Well Name: BURCH KEELY UNIT	Well Location: T17S / R29E / SEC 26 / NENW /	County or Parish/State: EDDY / NM
Well Number: 128	Type of Well: OIL WELL	Allottee or Tribe Name:
Lease Number: NMLC028784C	Unit or CA Name: BURCH KEELY UNIT	Unit or CA Number: NMNM88525X
US Well Number: 3001503131	Well Status: Producing Oil Well	Operator: SPUR ENERGY PARTNERS LLC

Notice of Intent

Type of Submission: Notice of Intent Type of Action: Plug and Abandonment

BKU 128 P&A Procedure

API #	30-015-03131	PROPOSED P&A BURCH KEELY UNIT 128	County, ST	Eddy County, NM
Operator	Spur Energy Partners		Sec-Twn-Rng	26-17S-29E
Field	GRAYBURG JACKSON		Footage	660 FNL, 1980 FWL
Spud Date	10/1/1949		Survey	32.810997, -104.0475845

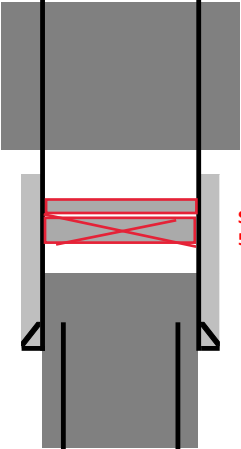
Set CIBP 50' above tag and leak test to 500psi, 30mins. Spot 25sx on top
